**TOWN OF MOUNTAIN VILLAGE  
REGULAR DESIGN REVIEW BOARD MEETING  
THURSDAY NOVEMBER 1, 2018 10:00 AM  
2nd FLOOR CONFERENCE ROOM, MOUNTAIN VILLAGE TOWN HALL  
455 MOUNTAIN VILLAGE BLVD, MOUNTAIN VILLAGE, COLORADO  
AGENDA**

**TO:** Design Review Board  
**FROM:** Sam Starr, Planner  
**FOR:** Meeting of November 1, 2018  
**DATE:** October 26, 2018  
**RE:** Consideration of a Final Review application for a new single-family dwelling on Lot 649R Unit 8, 8 Boulders Way

**RE:** Consideration of a Minor Revisions application to an approved landscape plan at Lot 1151, 132 High Country Drive

**1 LANDSCAPE PLAN**  
3/16" = 1'-0"

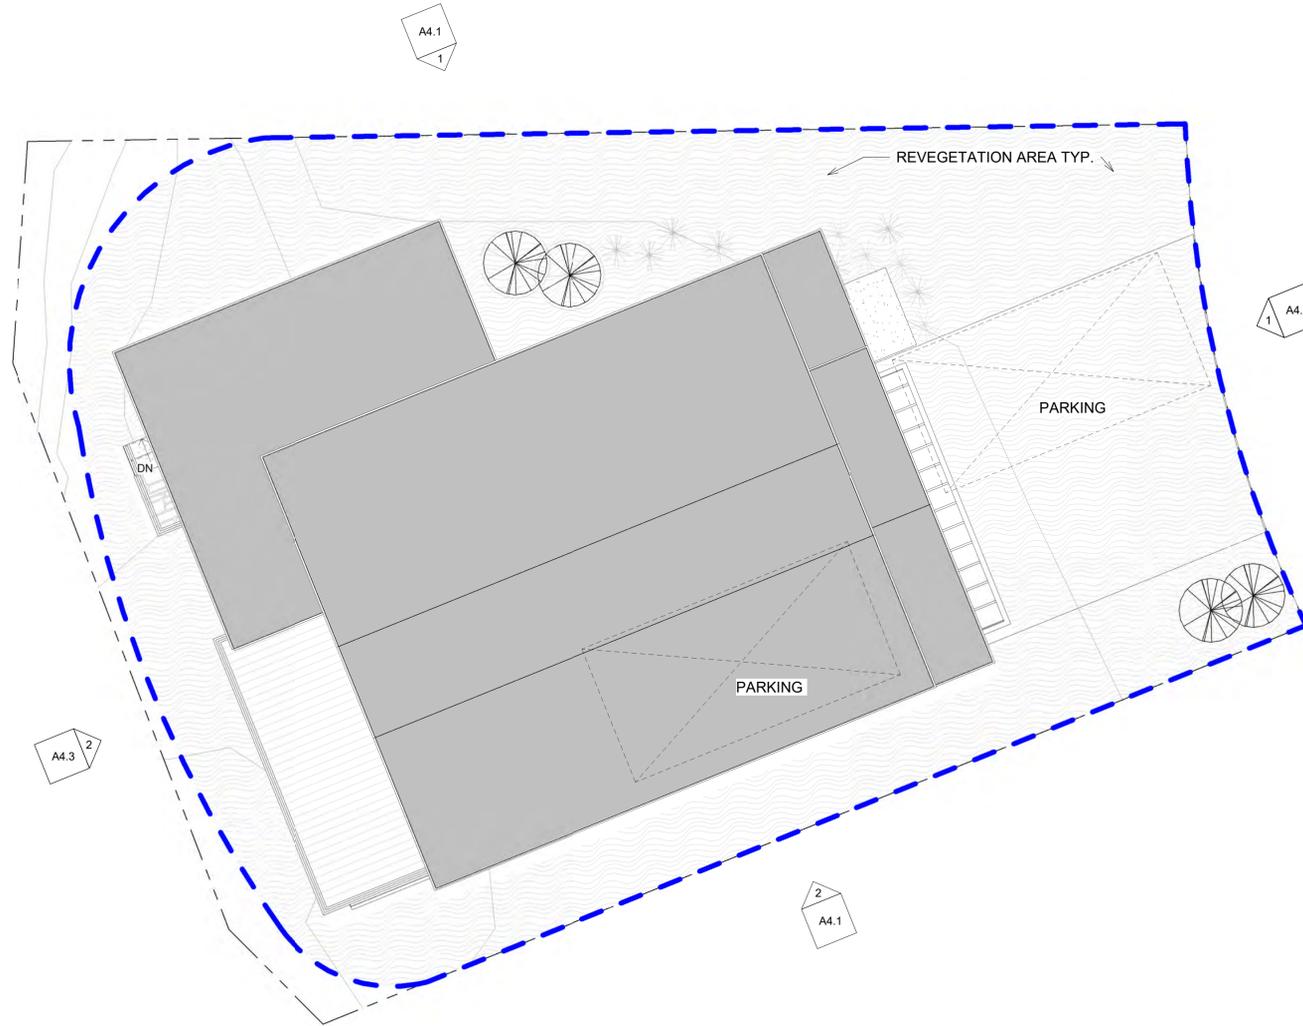
The applicant has submitted a landscape plan that shows 8 new Aspen and 11 new indigenous shrubs. All plantings will need to be in compliance with Table 5-4 of the CDC: Table 5-4, Minimum Plant Size Requirements

### CONSTRUCTION MITIGATION LEGEND

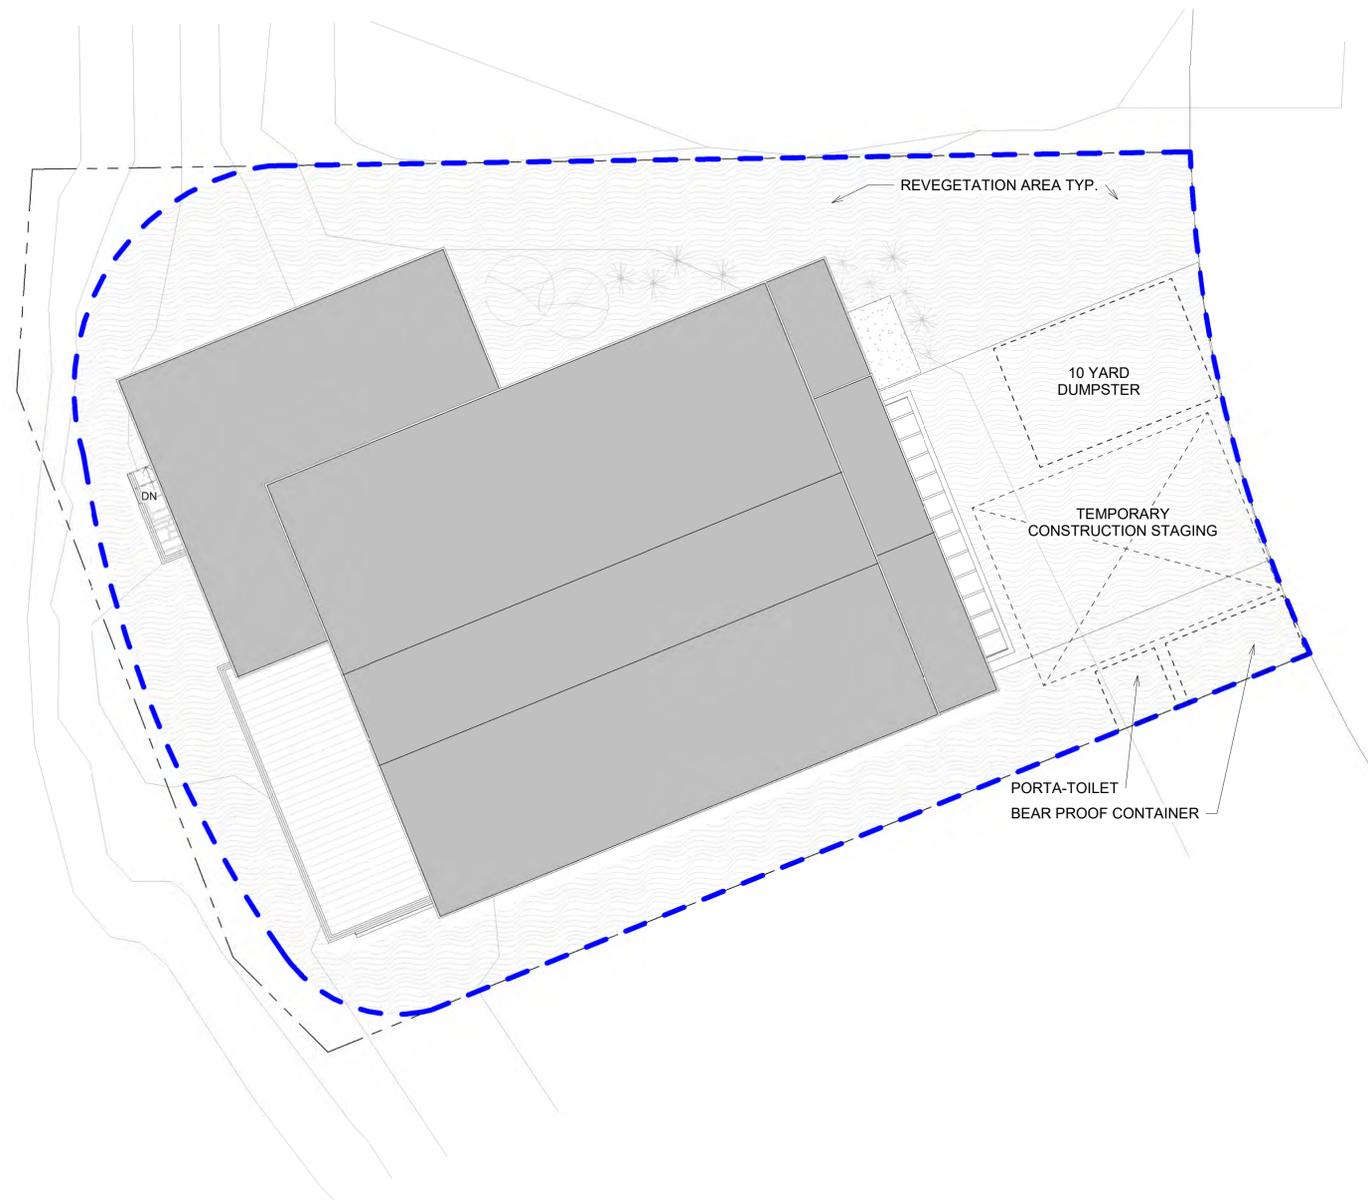
All construction staging is within the lot boundaries, and the fencing is on the setback line. Applicant has revised her original construction mitigation plan, and the final review version now reflects that all parking and staging will now be on Boulders lots 10 and 11.

**NOTE:**  
 STAGING AND PARKING  
 TO BE ON LOT 10 & 11

Revised Landscape Plan  
Scale 1" = 10'

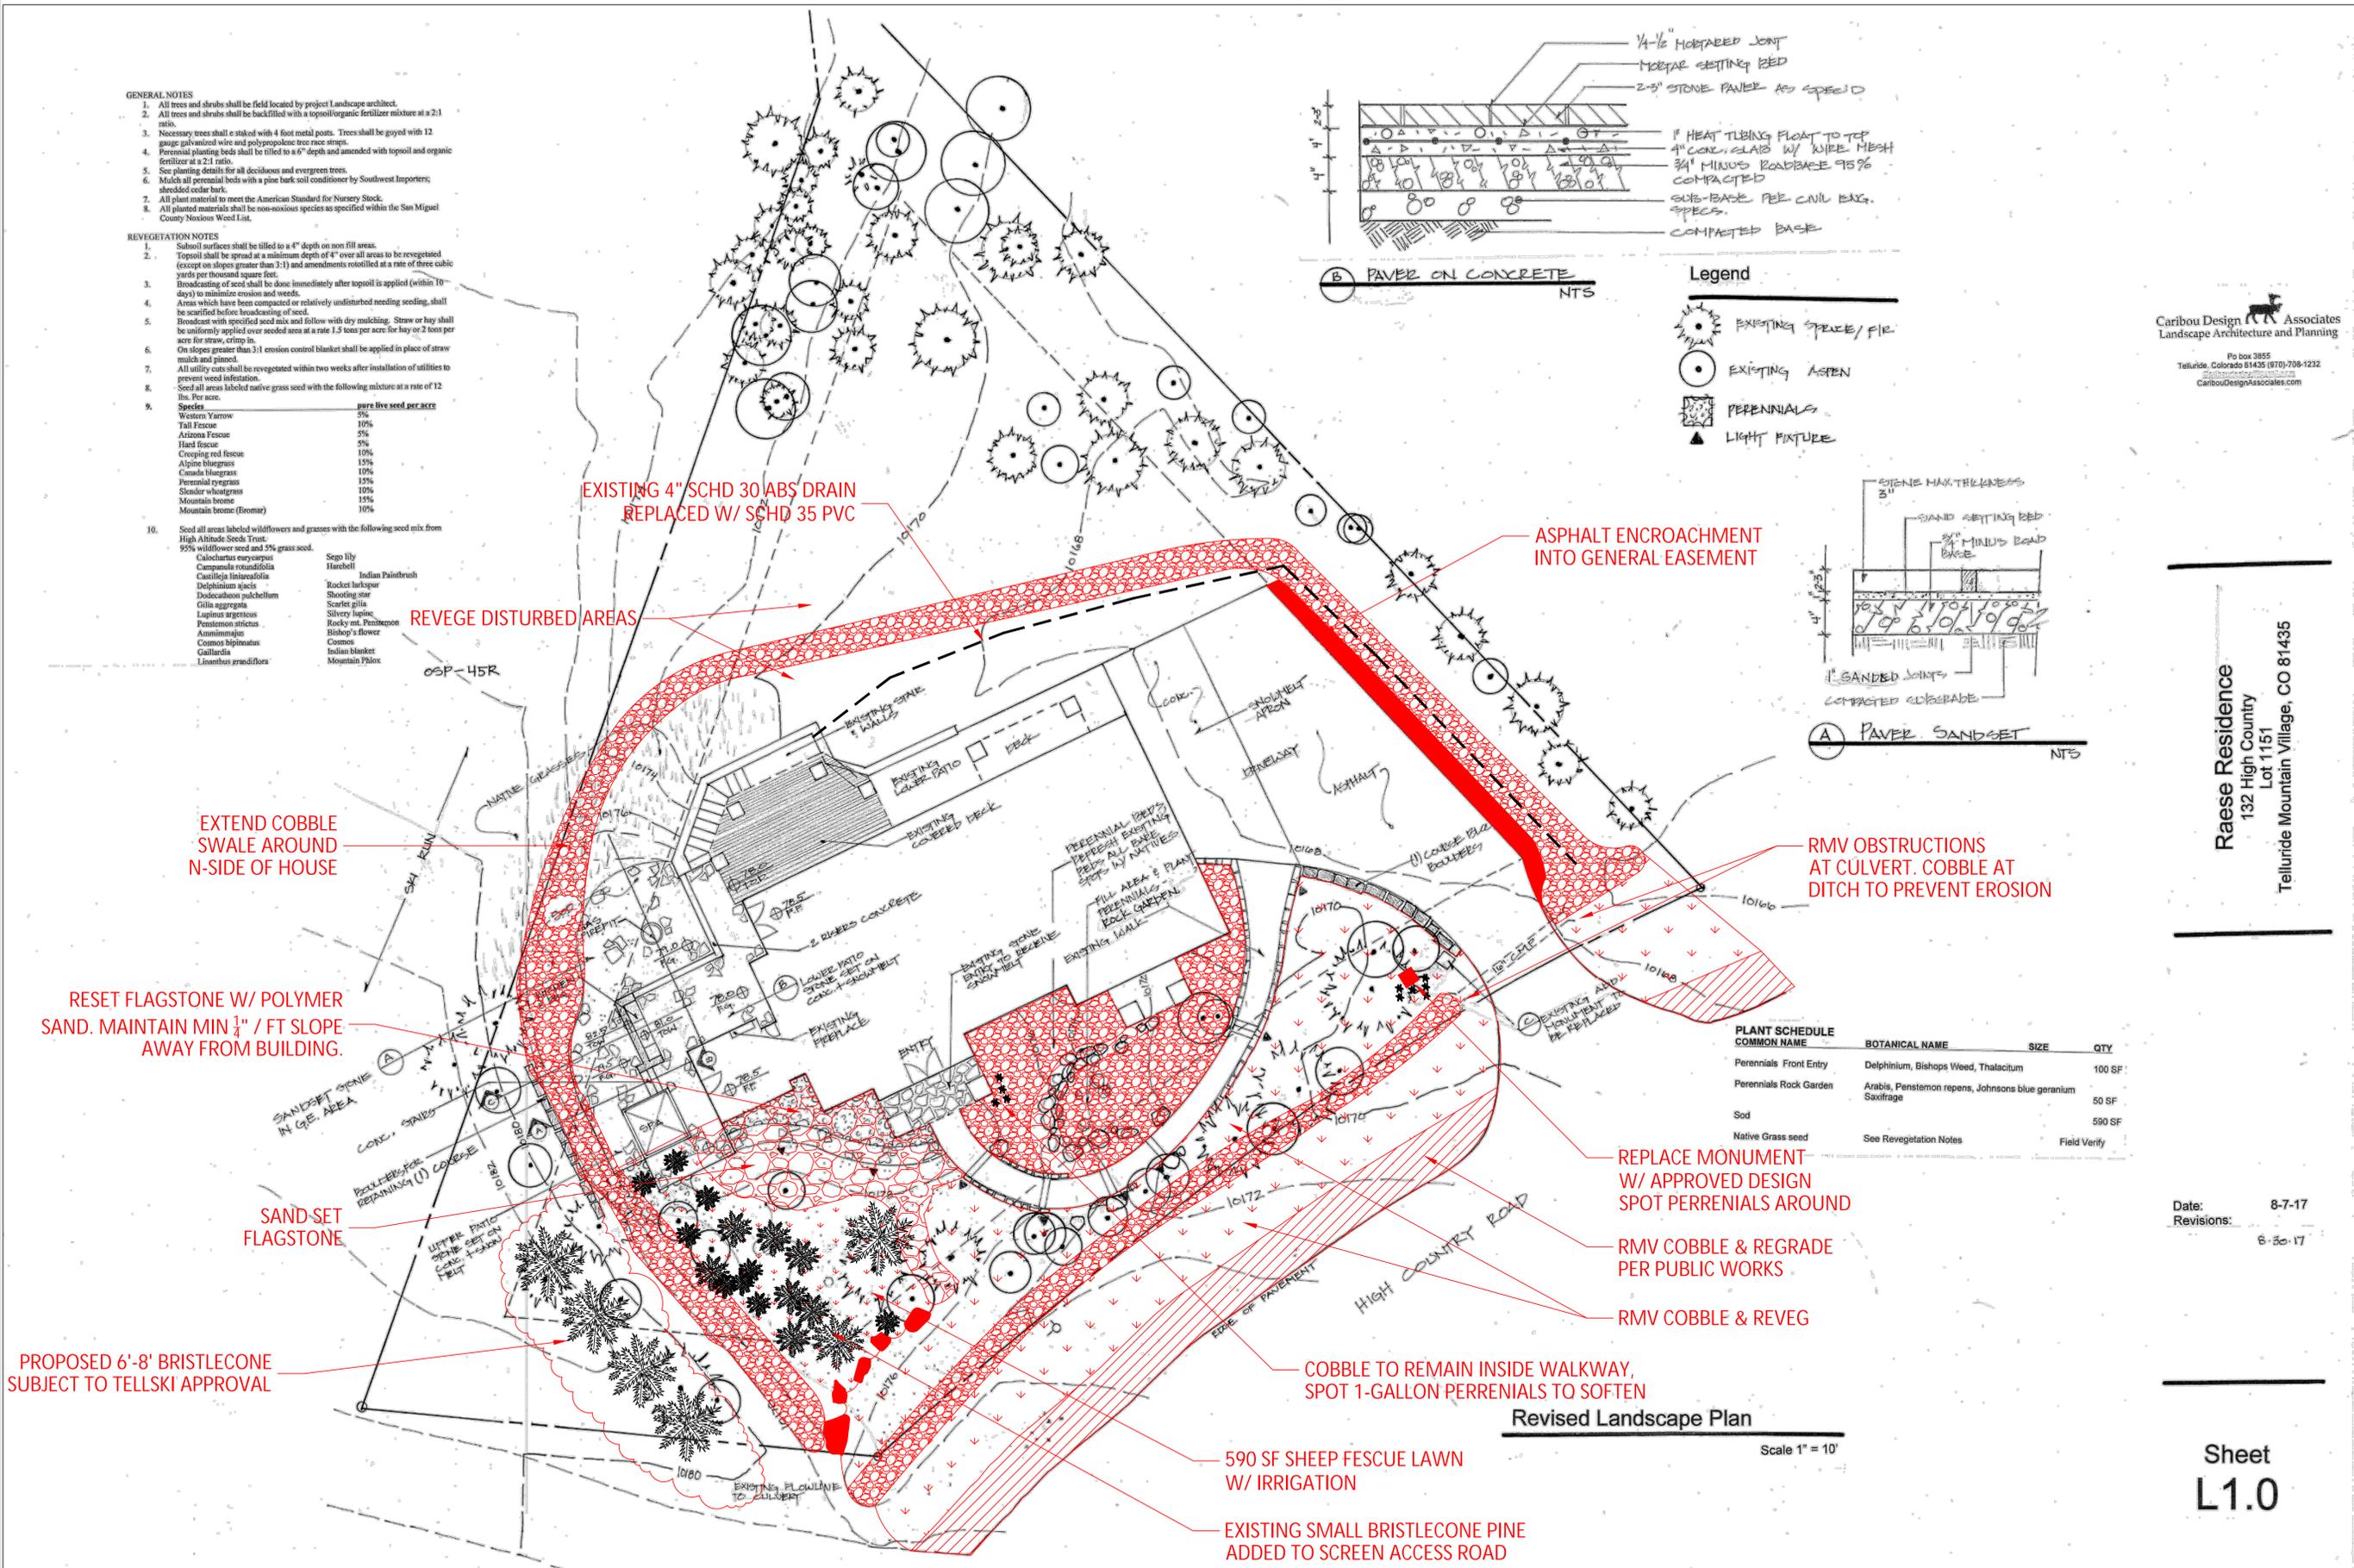
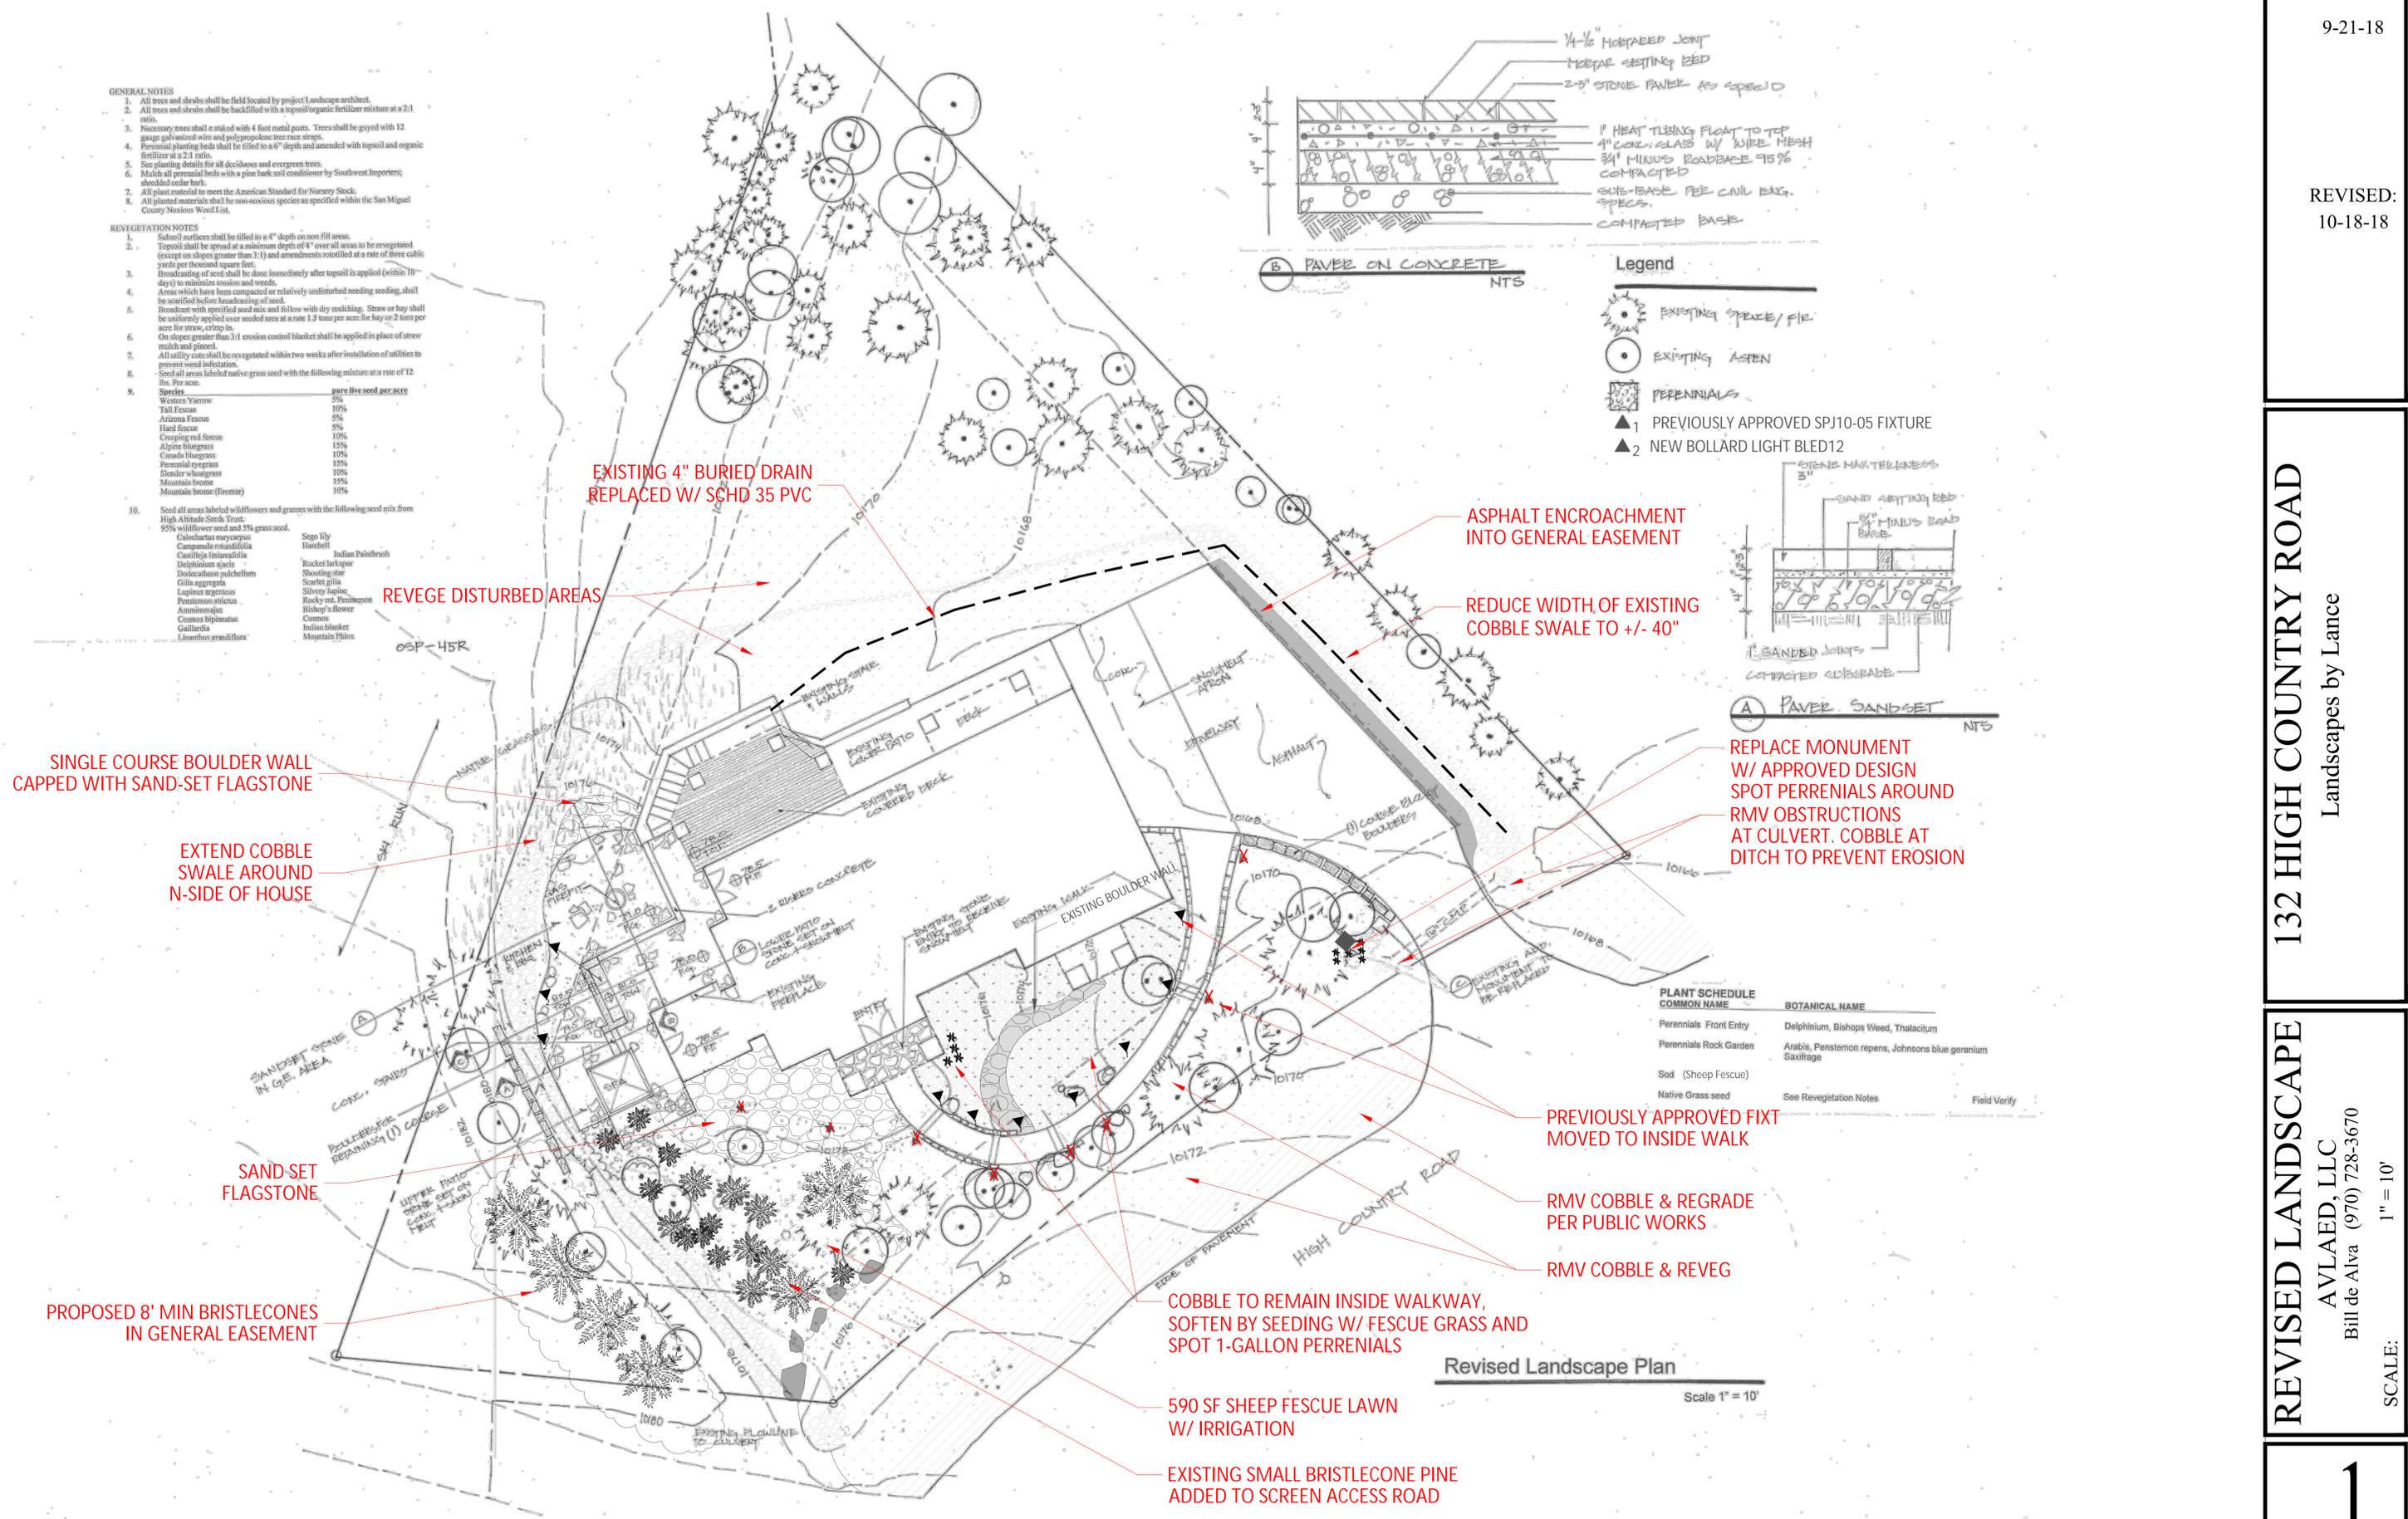
Staff Comment: The primary tree planted is bristlecone pine. The only variation requested is to the existing grouping of bristlecone pine which are less than 8' high and used for screening. The requested new bristlecone pines have been revised to meet the CDC requirement of a minimum of 8 feet in height.

Staff Comment. This was done for the purposes of screening the property from the adjacent TSG access road to the ski run. The applicant is requesting to plant 4 additional 8' minimum bristlecone pines. Staff has observed that a few of the bristlecone pines are in decline. The owner will have an obligation to replace these trees or remove them when dead. Assuring the trees have drip irrigation and the cobble does not otherwise negatively impact the growth of the trees is important for this application.

The applicant is addressing the most visible portions of the landscape plan which is from the street by removing cobble south of the stone walkway and replacing portions of existing cobble with sheep fescue lawn and irrigation. This will soften and improve the existing landscape plan from the street. The landscape plan recommends sheep fescue because it is heat and drought tolerant along with standing up to harsh conditions. Although cobble is shown to remain adjacent to the house and to the south which is the entrance, the applicants also indicate softening the area with 1-gallon perennials.

The applicant can better explain the need for cobble on each side of the property which is atypical from the prior landscape plan. Cobble is also shown to the south (front) of the property with spot 1-gallon perennials to soften. Removal of cobble on the front of the property has already improved the aesthetic from High Country Drive.

- Reduce the width of the proposed cobble swale to the north from 4 feet to 2 feet.
- Extend the cobble swale to the north and west to tie in with existing cobble swale.
- Regrade a portion of the flagstone patio to provide positive drainage.
- Reduce the width of the cobble by approximately 40" in the east general easement.
- Remove cobble to the south (south of front walkway) and landscape.
